**PROPOSED REVISIONS TO TECHNICAL SPECIFICATION CHANGES ASSOCIATED WITH
PRESSURE-TEMPERATURE AND OVERPRESSURE PROTECTION SYSTEM
LIMITS FOR UP TO 13.3 EFFECTIVE FULL POWER YEARS**

NEW YORK POWER AUTHORITY
INDIAN POINT 3 NUCLEAR POWER PLANT
DOCKET NO. 50-286
DPR-64

**SAFETY EVALUATION OF REVISED
PROPOSED TECHNICAL SPECIFICATION CHANGES ASSOCIATED WITH
PRESSURE-TEMPERATURE AND OVERPRESSURE PROTECTION SYSTEM
LIMITS FOR UP TO 13.3 EFFECTIVE FULL POWER YEARS**

**MARK-UP OF REVISED TECHNICAL SPECIFICATION PAGES ASSOCIATED WITH
AMENDMENT REQUEST FOR PROPOSED TECHNICAL SPECIFICATION CHANGES
ASSOCIATED WITH PRESSURE-TEMPERATURE AND OVERPRESSURE PROTECTION
SYSTEM LIMITS FOR UP TO 13.3 EFFECTIVE FULL POWER YEARS**

FIGURE 3.1-2
Reactor Coolant System Cooldown Limitations - Indian Point 3

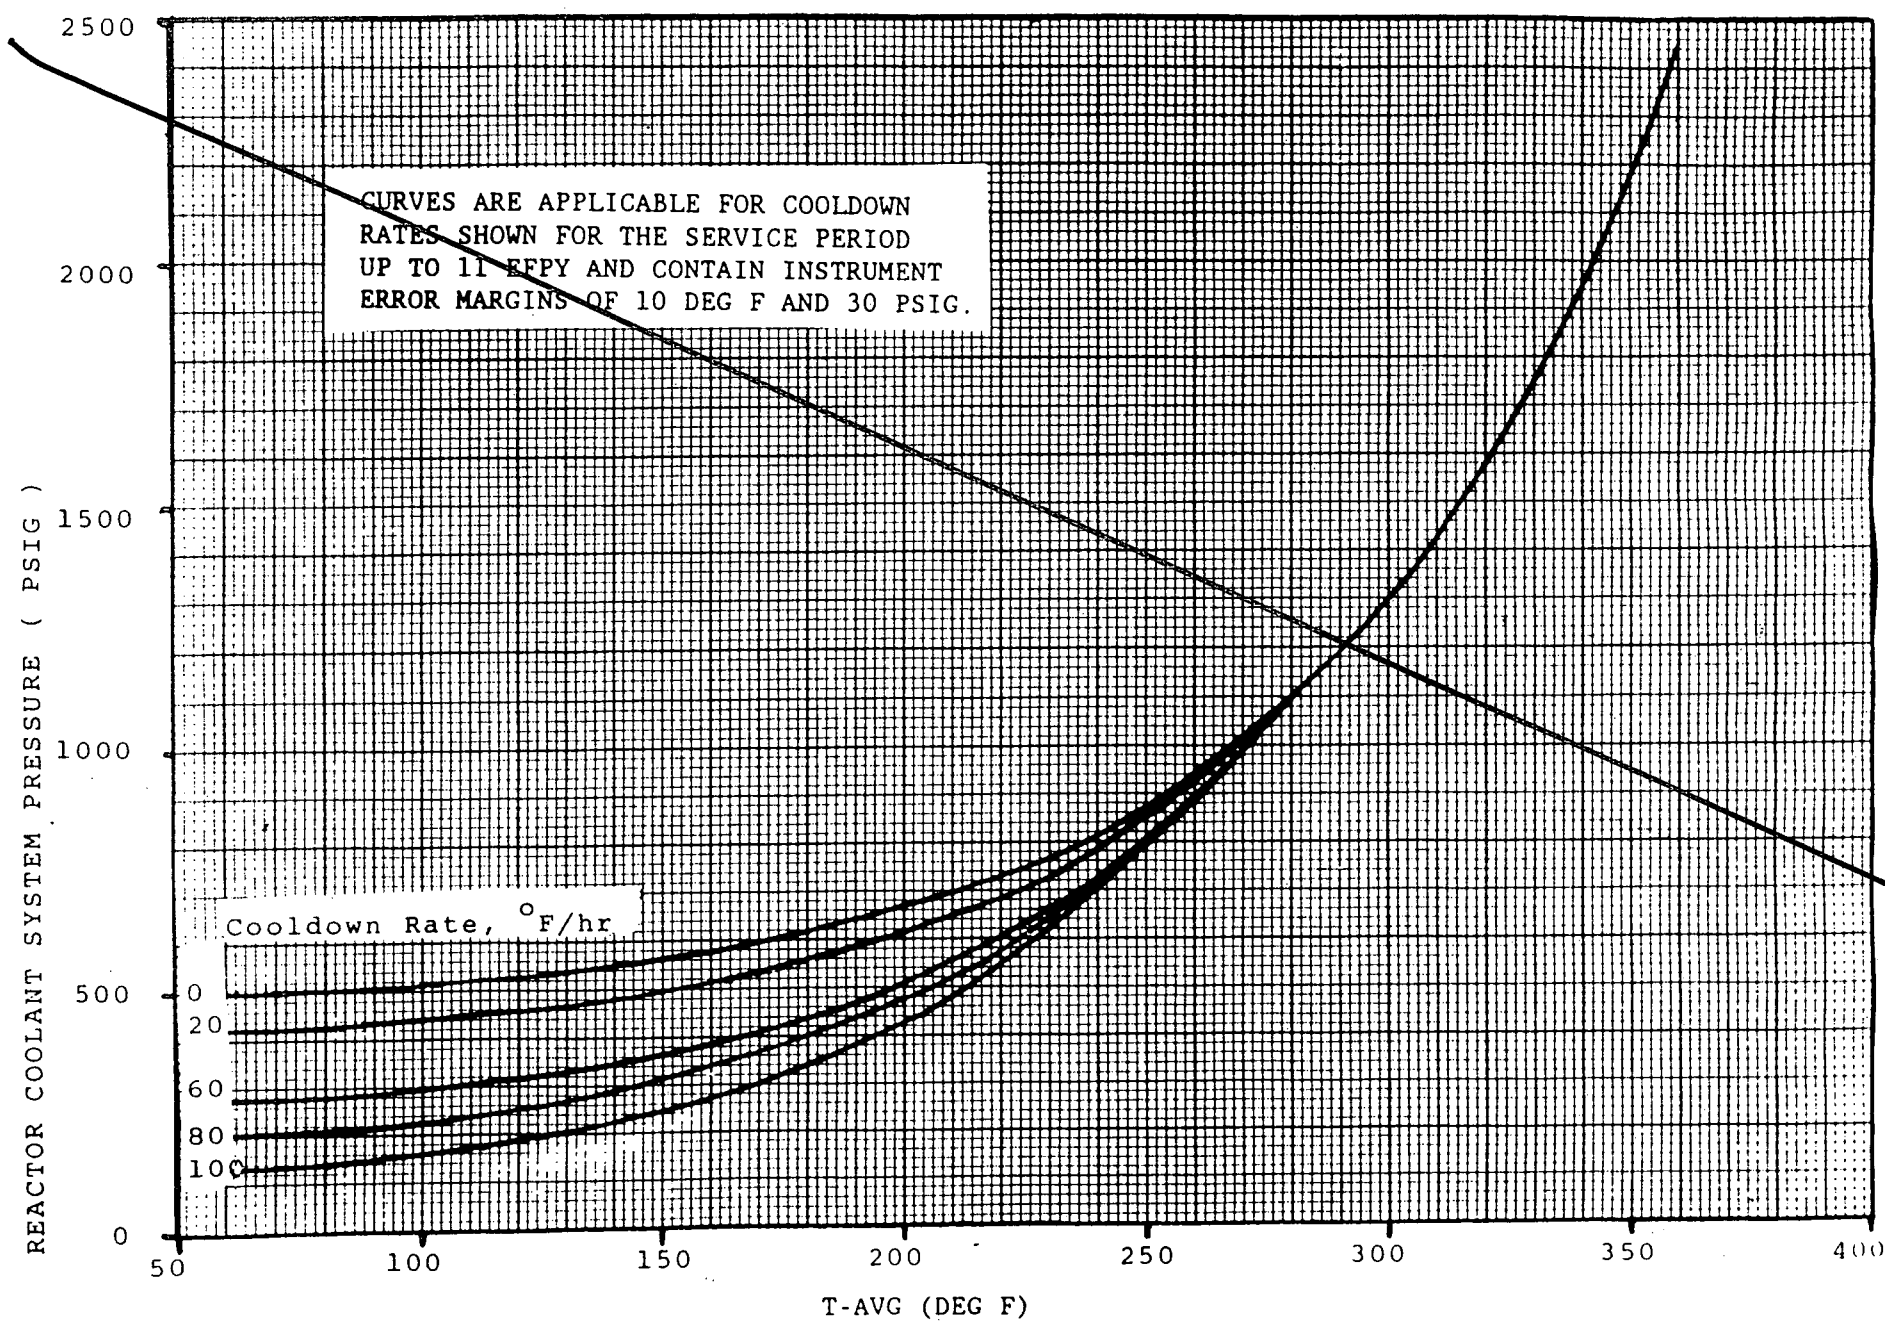
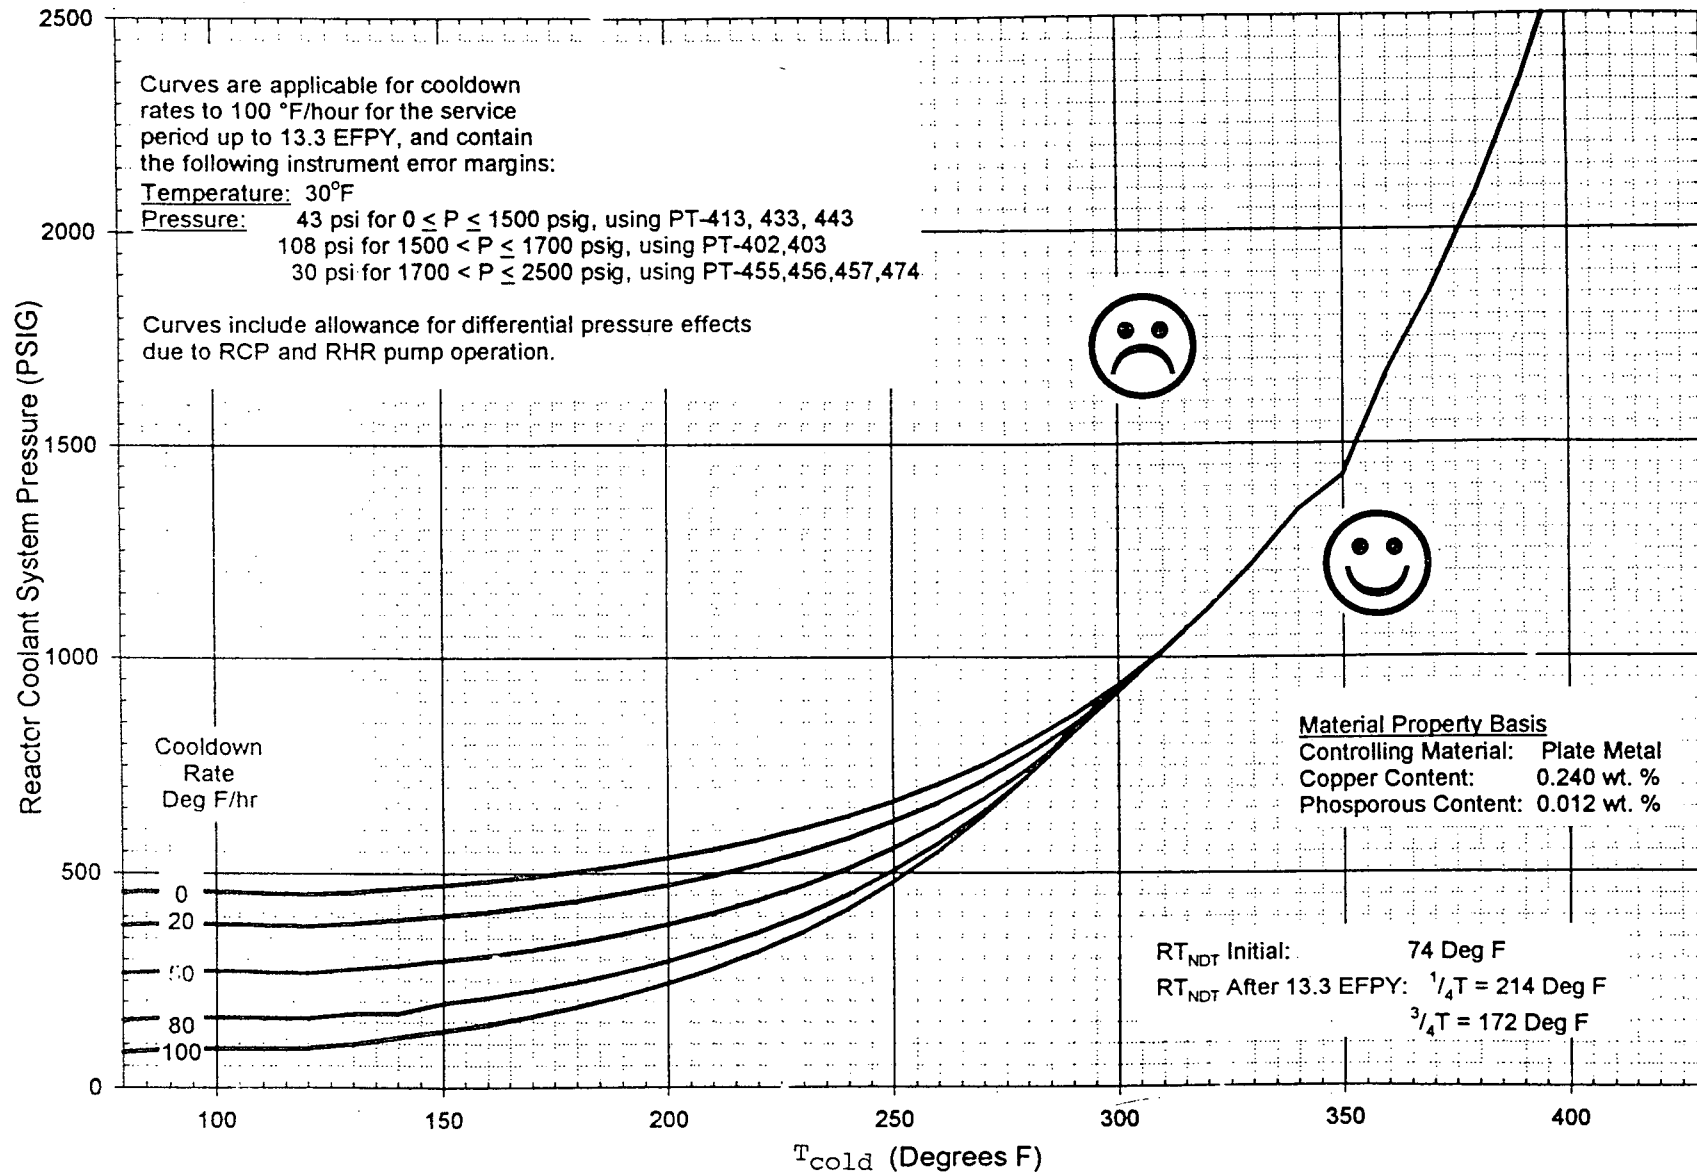
RT_{NDT} INITIAL: 74°F
 RT_{NDT} AFTER 11 EFPY: 1/4T = 202°F
 3/4T = 163°F

REPLACE WITH ATTACHED PAGE

FIGURE 4.3-1
Pressure/Temperature Limits for Hydrostatic Leak Test

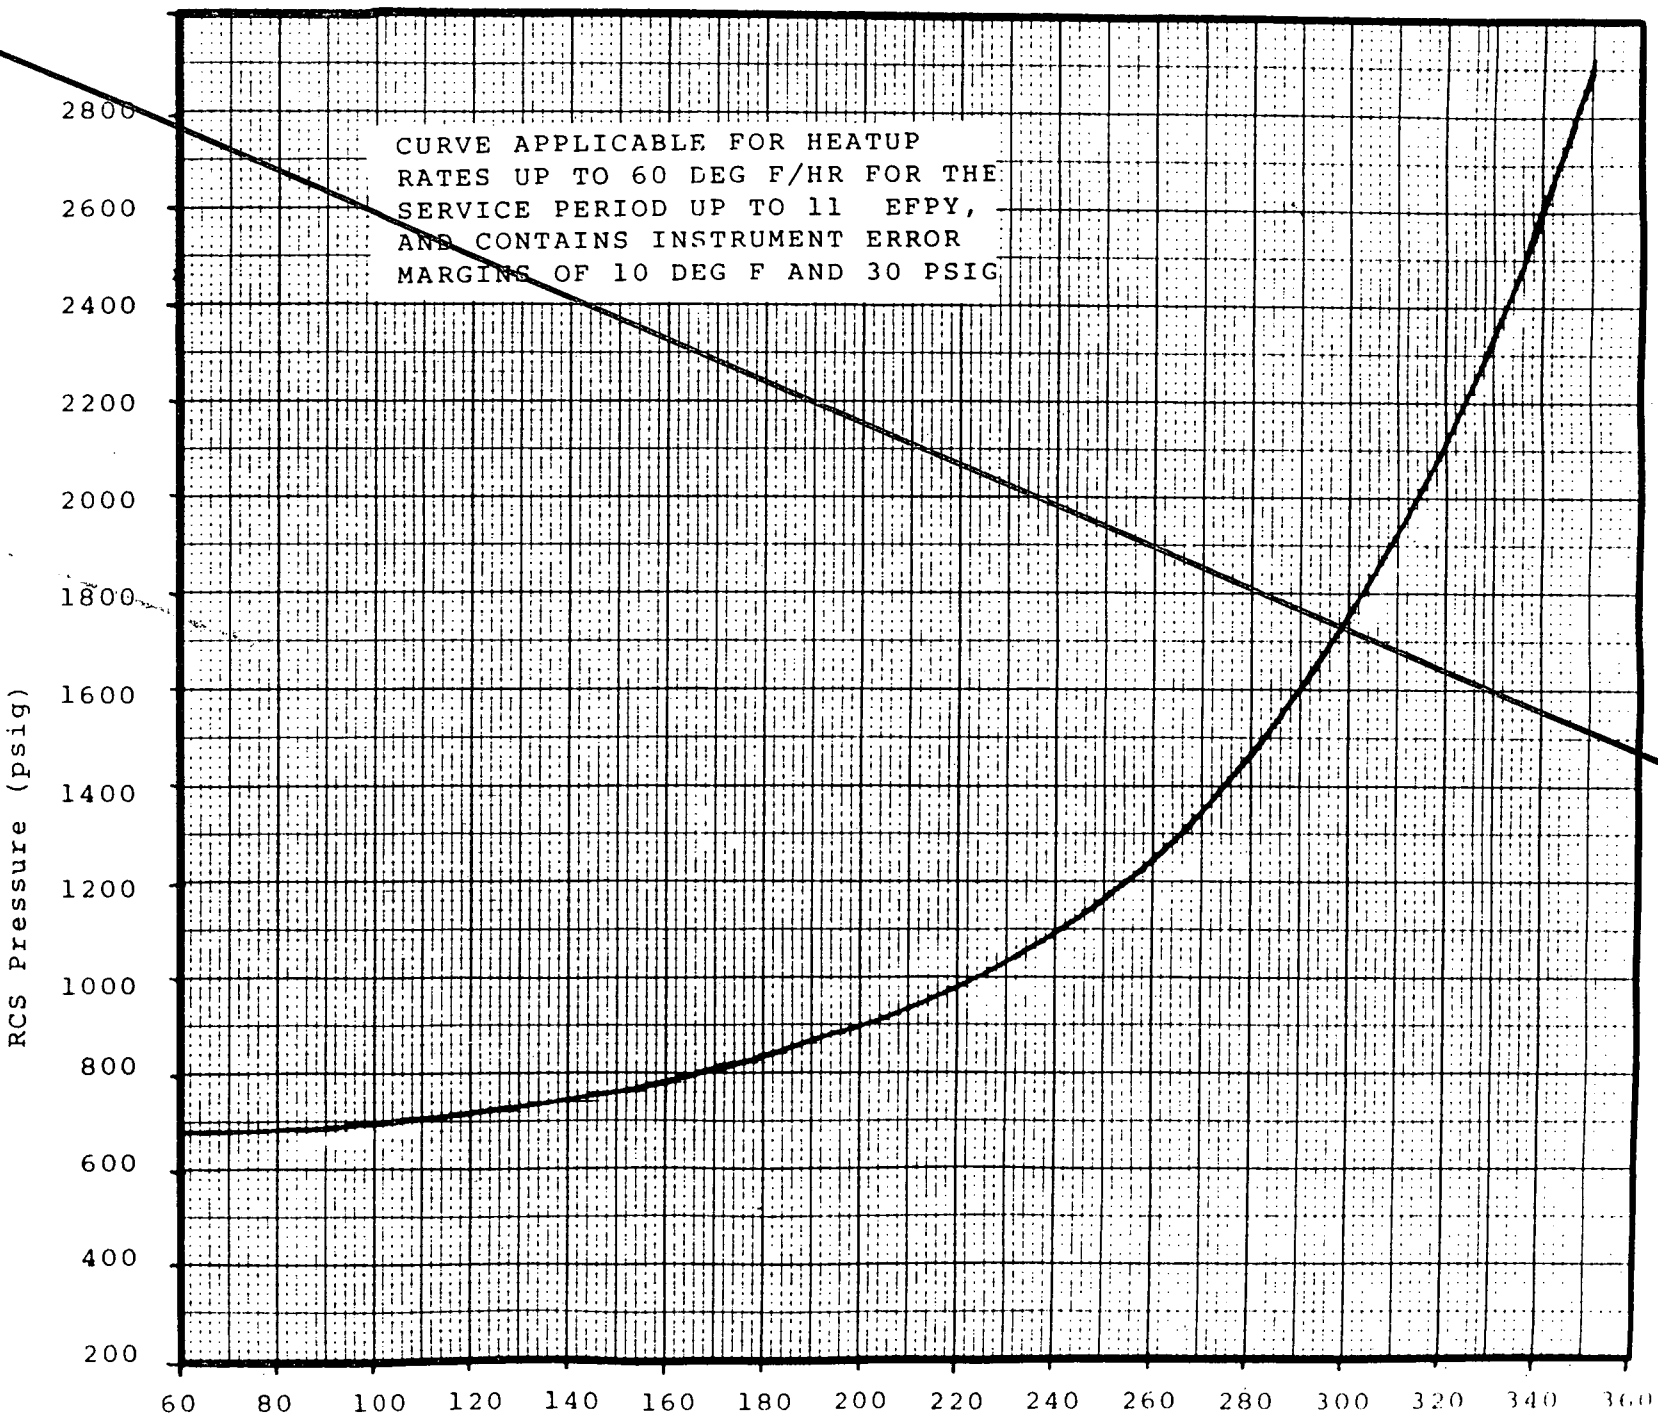
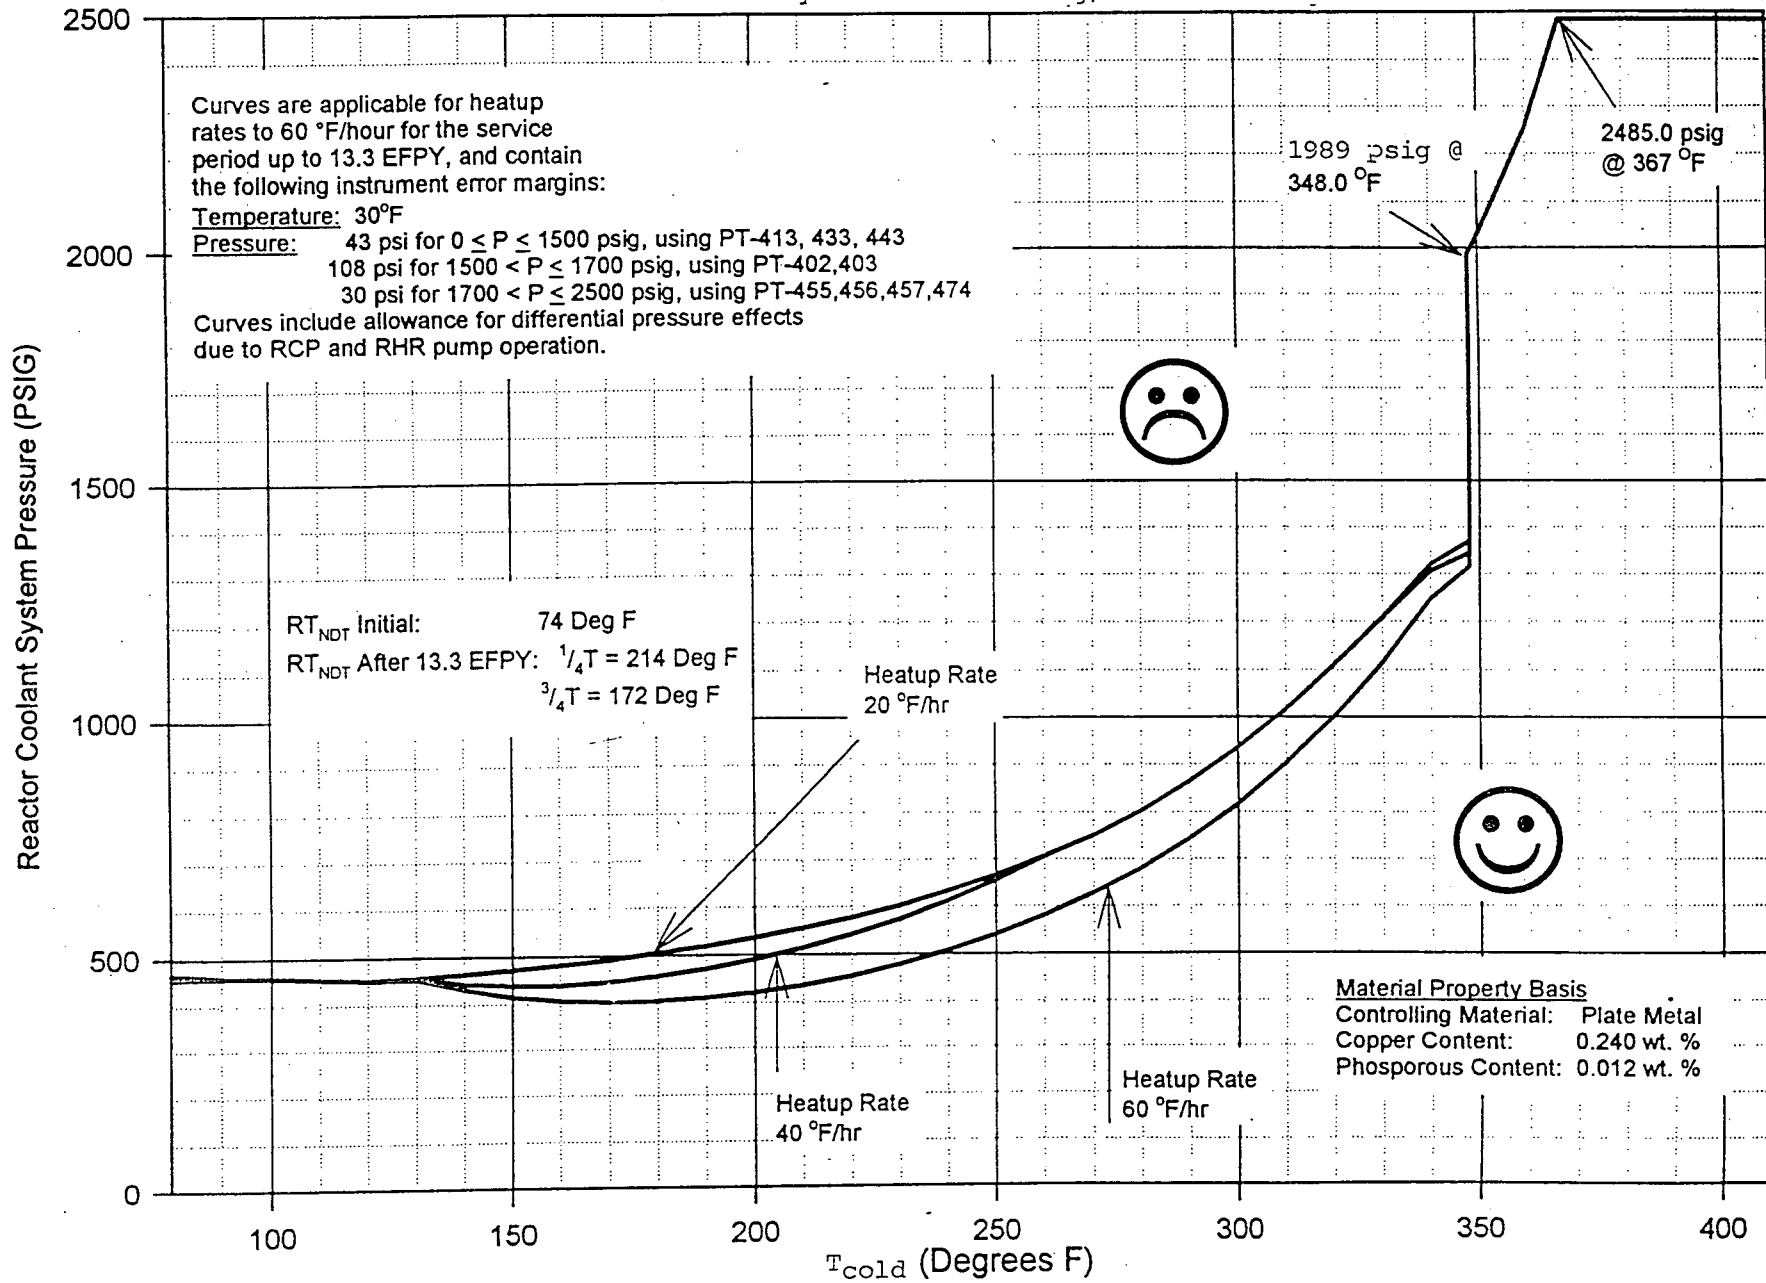
For the first ~~11.00~~ 13.3 effective full power years, it is predicted that the highest RT_{NDT} in the core region taken at the 1/4 thickness will be ~~202°F~~ 214°F. The temperature determined by methods of ASME Code Section III for ~~2335~~ 1989 psig is ~~133°F~~ 134°F above this RT_{NDT} and for ~~2510~~ 2485 psig (maximum) is ~~143°F~~ 153°F above this RT_{NDT} . The minimum inservice leak test temperature requirements for periods up to ~~11.00~~ 13.3 effective full power years are shown on Figure 4.3-1⁽²⁾.

74°F
1/4 T = 202°F
3/4 T = 163°F

RCS Limitations for Hydrostatic Testing, 13.3 EFPY
